2. 11 Mall Road - Game On & Loretta's Last Call

PLANNING BOARD AGENDA FOR JANUARY 13, 2026 - 7:00 PM

Below please find our responses comments discussed in our December 9, 2025 meeting and at the PB meeting. Below please find each comment followed by our response in **bold.**

LYONS GROUP RESTAURANT
AT THE MALL AT ROCKINGHAM PARK
PLANNING BOARD SUBMISSION

12/29/25	RESPONSE TO COMMENTS	1
CS101	EXTERIOR SITE PLAN

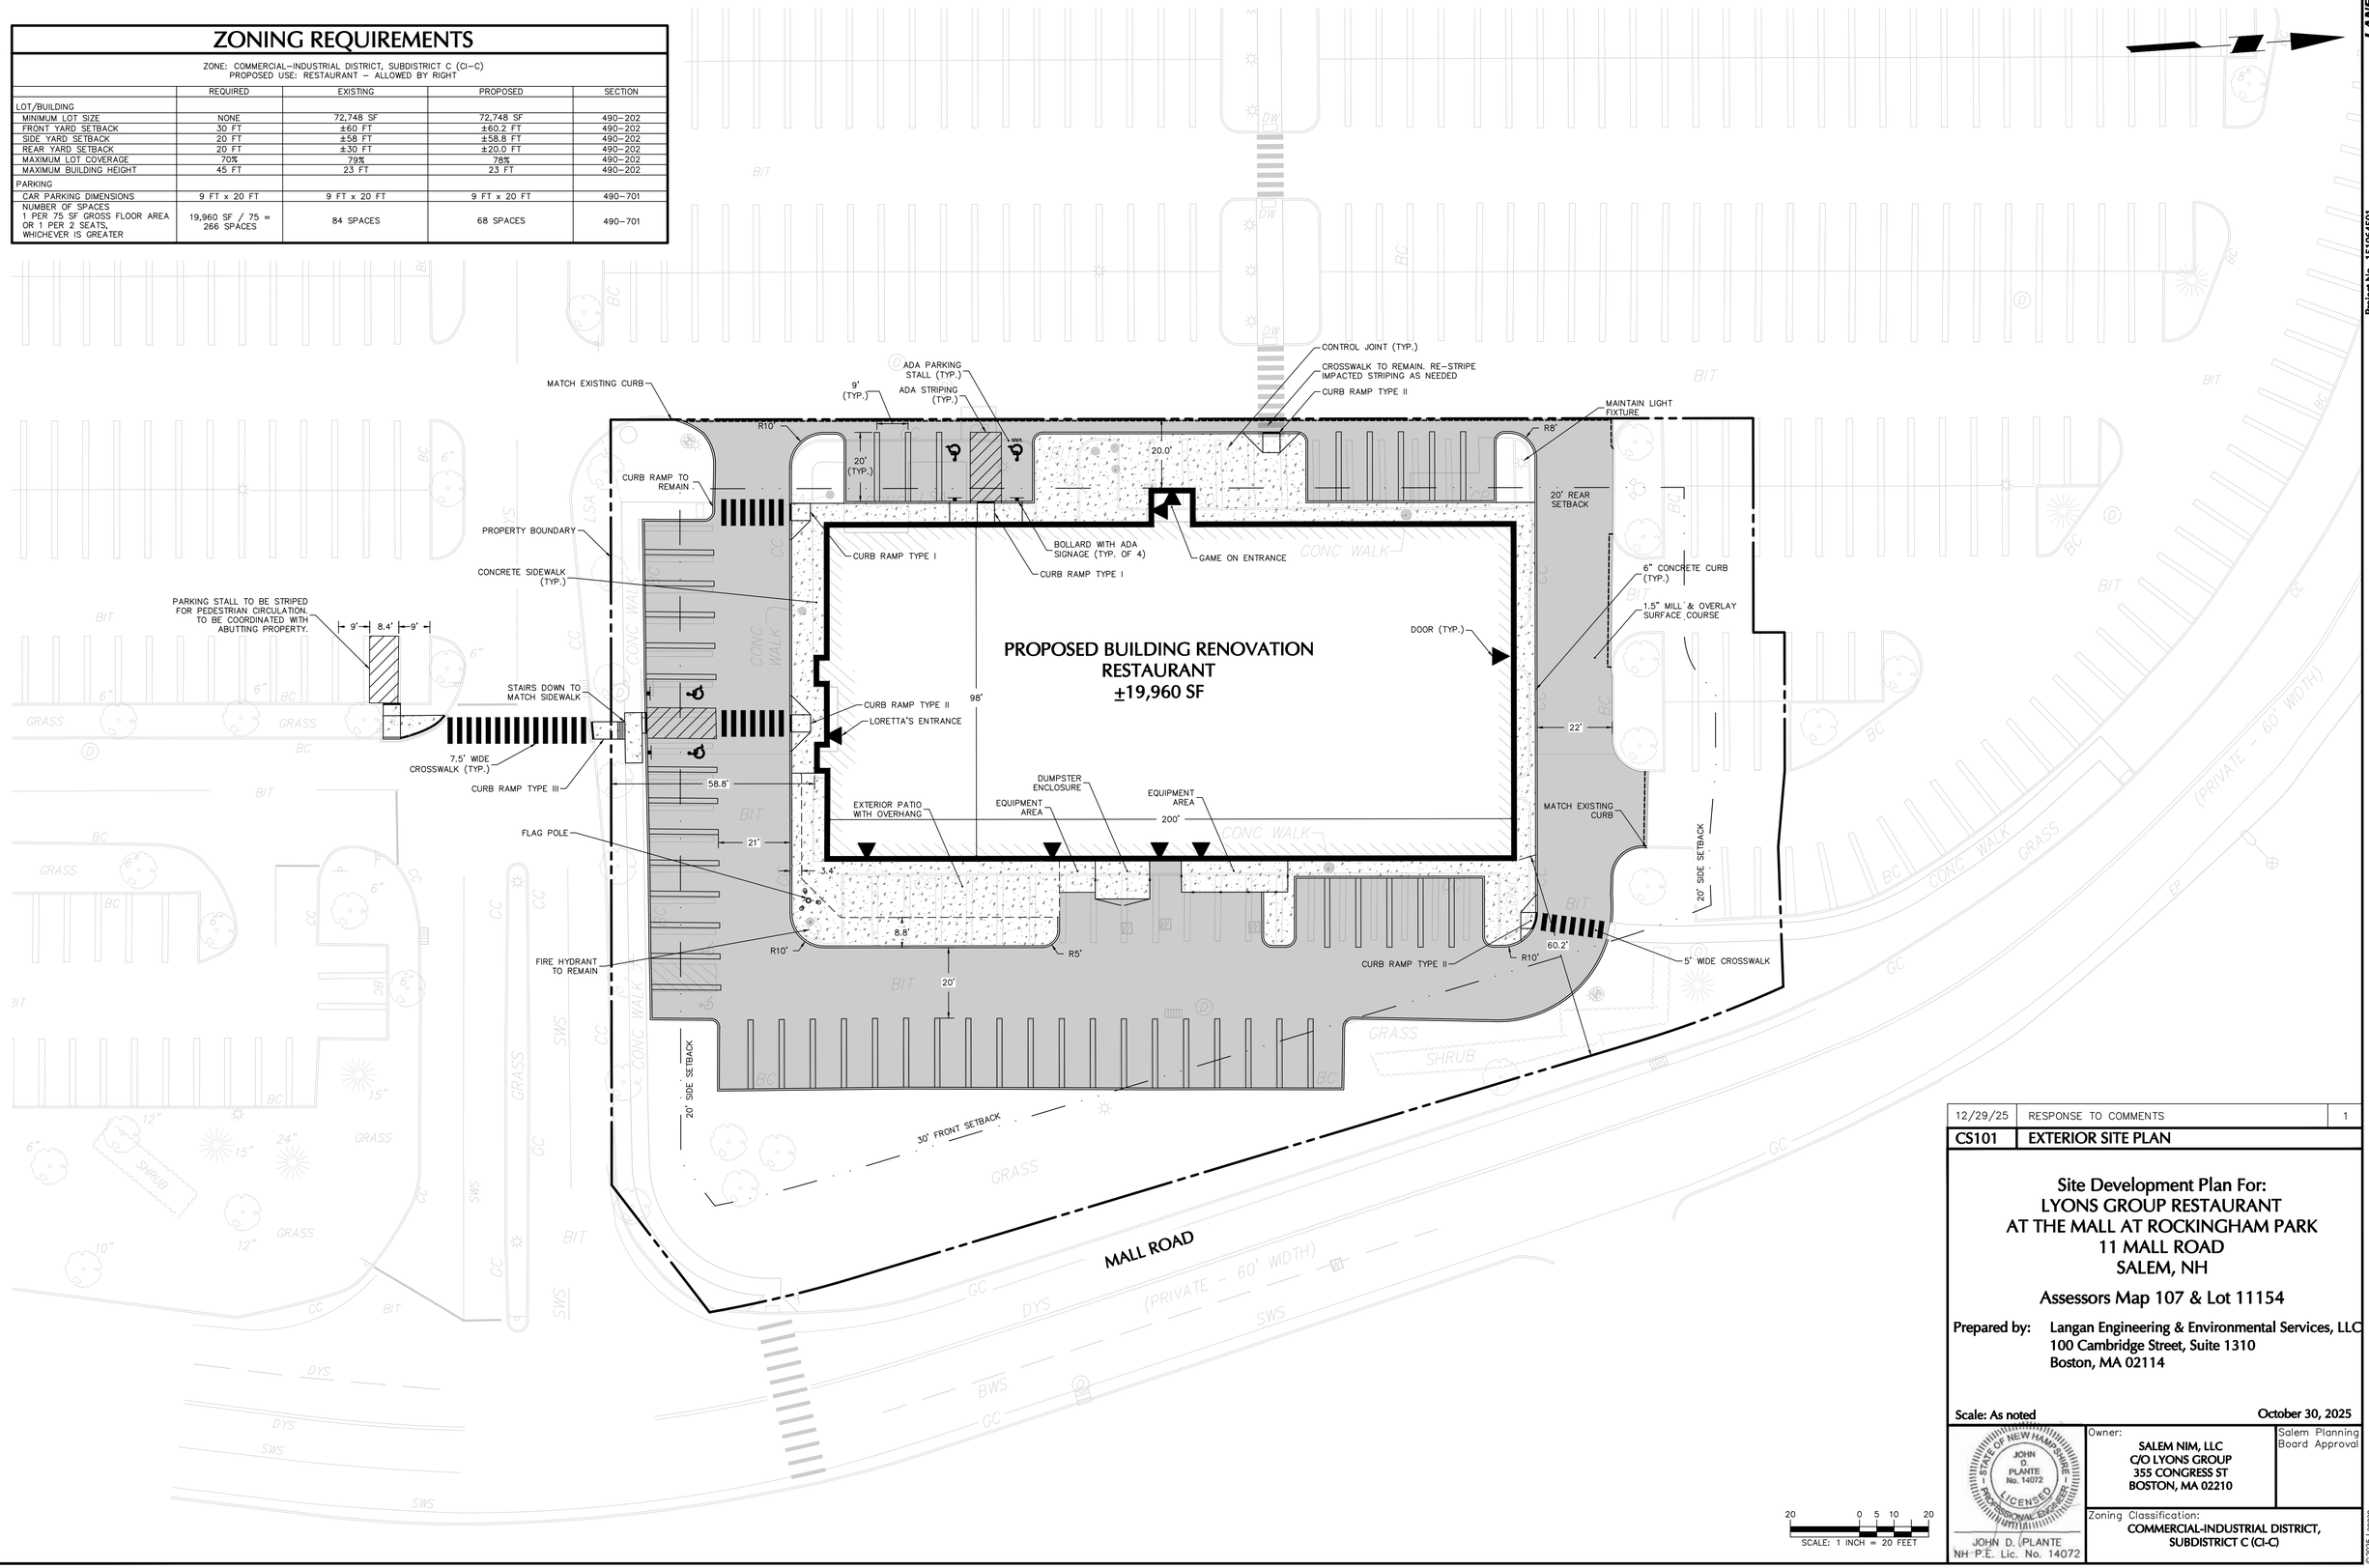
- Site Plan:
  - Add pedestrian connection to north sidewalk

- Add tip down at ADA spaces to ped. connection to south

- Add dimension of striped space to south

COMMENT RESPONSE: Curb ramp with crosswalk has been added to the plans. Please see CS101.

COMMENT RESPONSE: Tip down to ADA spaces has been added to south sidewalk connection, as seen on CS101.

COMMENT RESPONSE: Dimensions have been added to restriped southern parking area, seen on CS101.

EXTERIOR ELEVATIONS

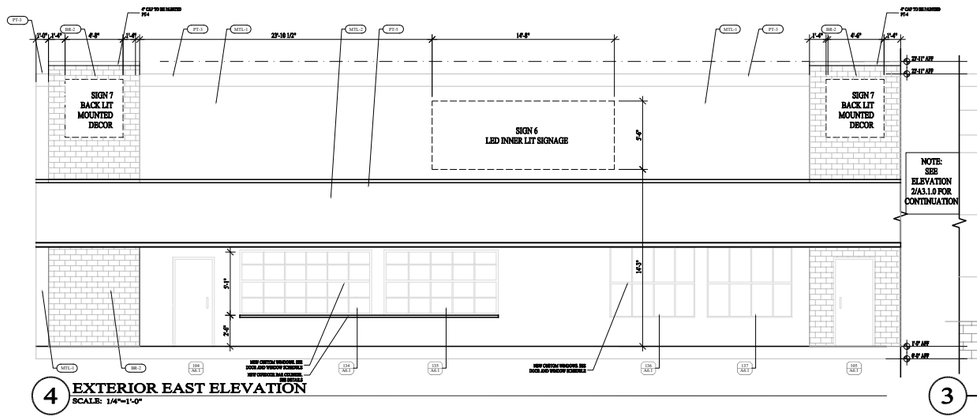
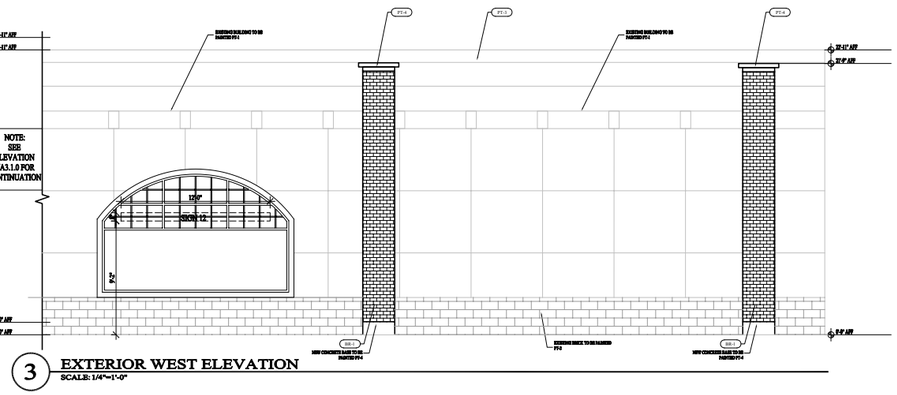
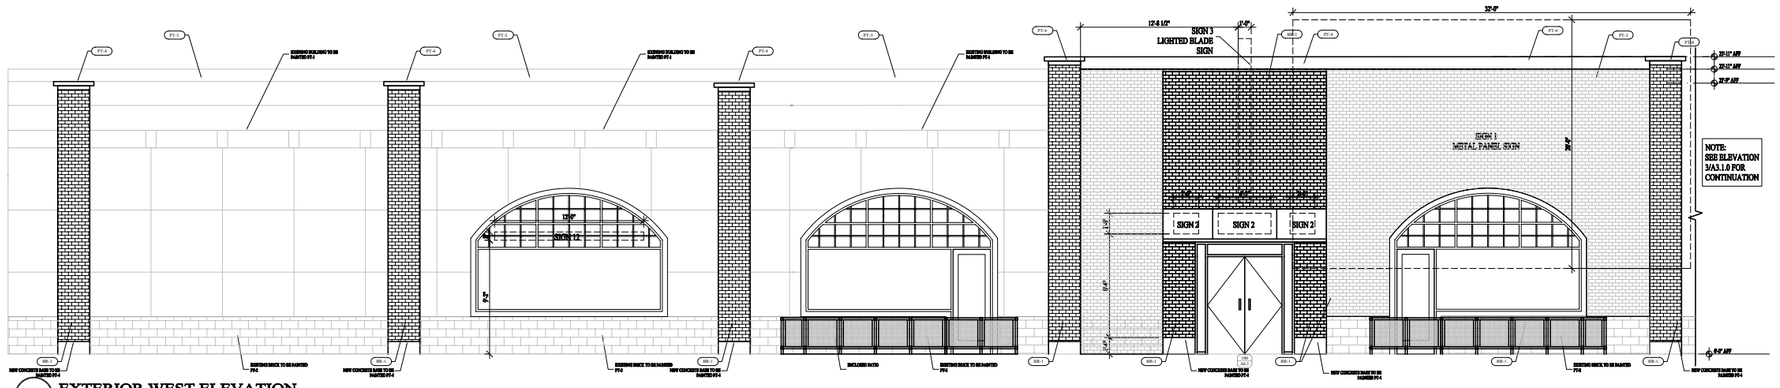
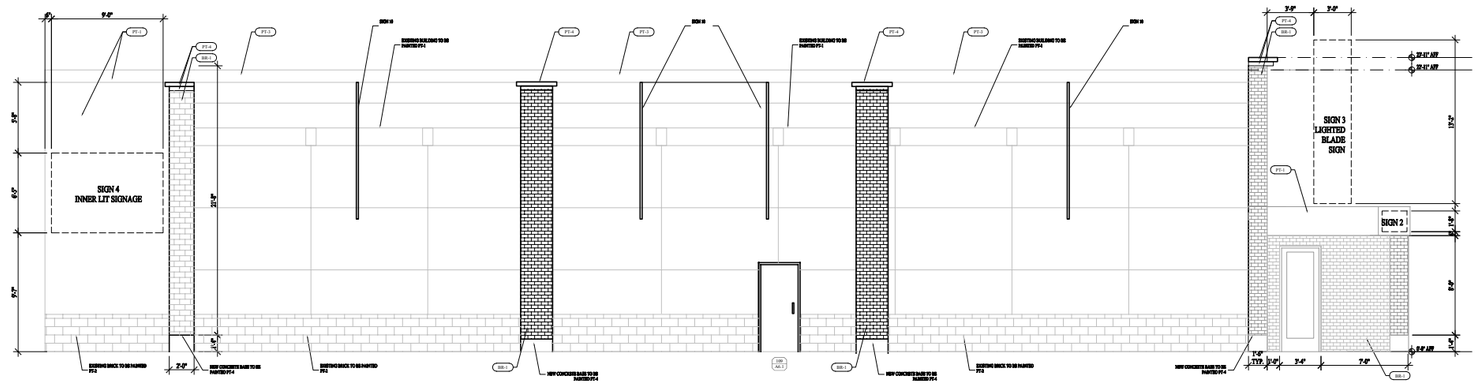
fence; adding new brick for equipment storage and dumpster enclosure. Proposed modifications are attractive and welcomed improvements however building has blank walls on large portions of western, northern and eastern facades and eliminated transparency on western facade Elevations should still be revised to better comply with Site Plan Regulations and Design Guidelines (see excerpts attached) – specifically to reduce blank walls, increase transparency, vary roofline; dumpster enclosure should be revised to match building."

COMMENT RESPONSE: This concern was addressed by adding the large window on either side of the entrance as well as two additional large windows beyond those two windows that are decorative. In addition, we have added banners on the North side of the building as well as an additional pilaster on the east face behind the equipment enclosure.

COLORED EXTERIOR ELEVATIONS

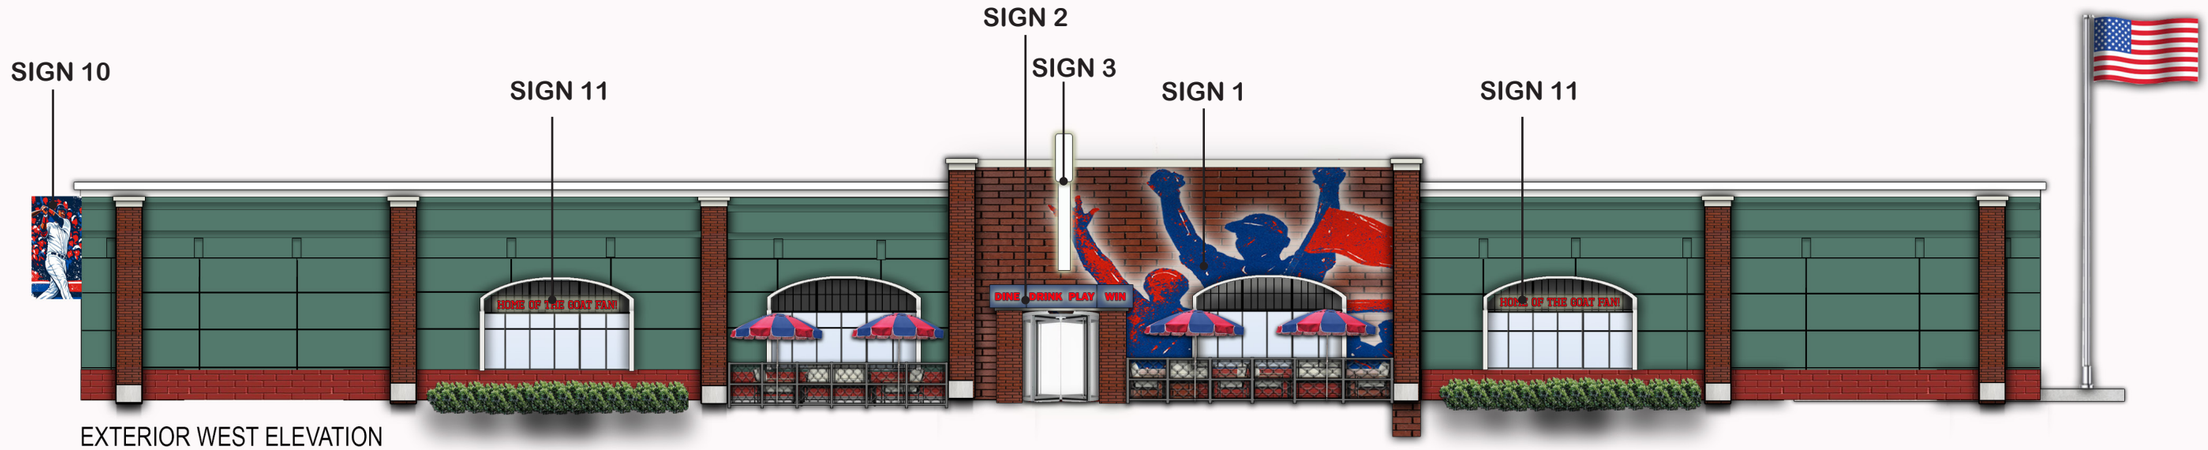
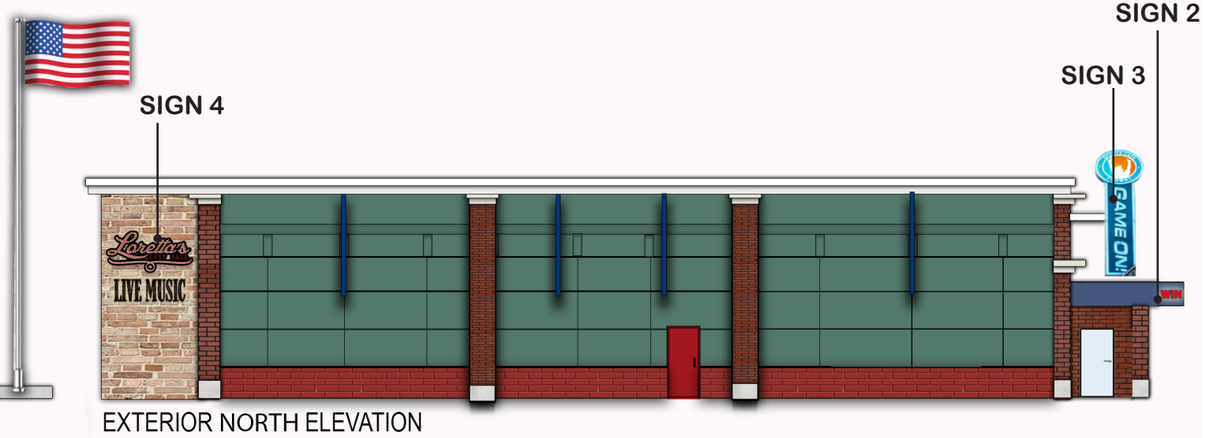
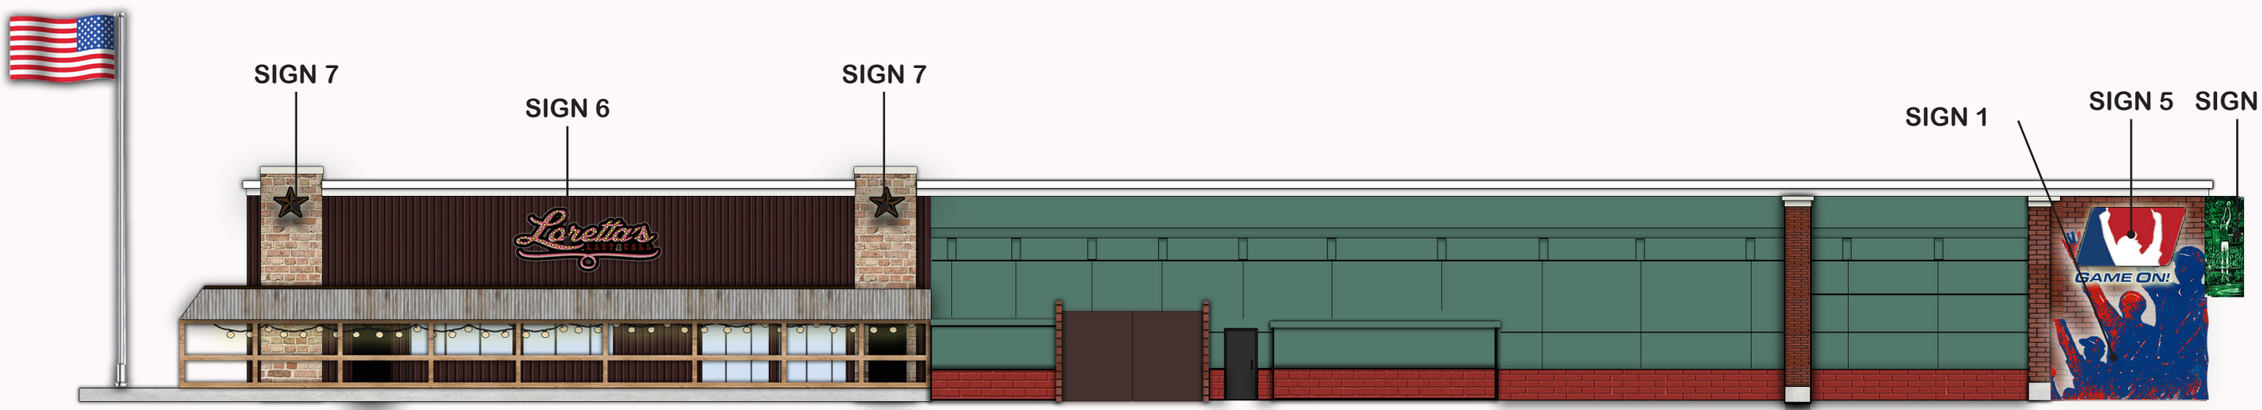
- Elevations:
  - Add legend – materials and color

COMMENT RESPONSE: **Additional page has been added to the plans with the legend.**
